**Recall Information Bulletin**

**No:** C1004110 **Issued:** 2/17/2010  
**NHTSA No:** 09V-449  
**Transport Canada No:** 09-325  
**Re:** Air Intake Duct  
**Group:** 15 **Models:** FE,FG

Safety Recall C1004110 - Air Intake Duct

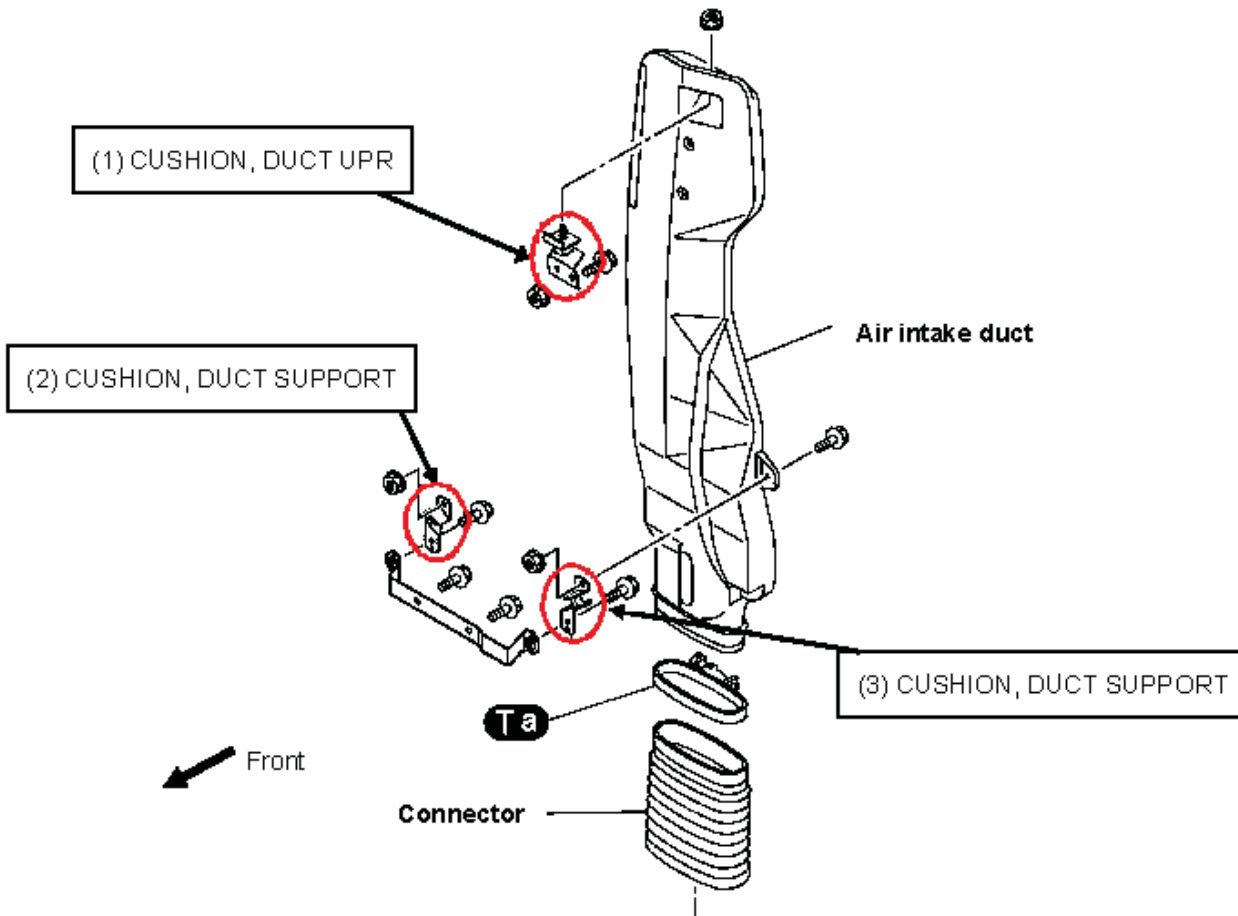
Mitsubishi Fuso Truck of America, Inc. has decided that a defect which relates to motor vehicle safety exists in the air intake bracket rubber cushions. On affected vehicles, the weather resistance properties of the air intake duct rubber cushions are insufficient. During normal vehicle operation, the rubber cushions deteriorate and crack, causing abnormal noise. In the worst case, all of the rubber cushions could crack, allowing the air intake duct to fall off of the truck.

Install improved air intake duct rubber cushions.

The air intake duct rubber cushions will be replaced. The replacement parts kit **EX54A** is available through normal parts channels.

1. Park the vehicle on a flat, level surface, shut off the engine, apply the parking brake, chock the wheels and disconnect the battery cables. **CAUTION! Do not remove the wheel chocks until all modification work has been completed!**
2. Remove the air intake duct. Replace the upper duct cushion and two duct support cushions.
3. Tighten all hardware in accordance with the Tightening Torque Table below.
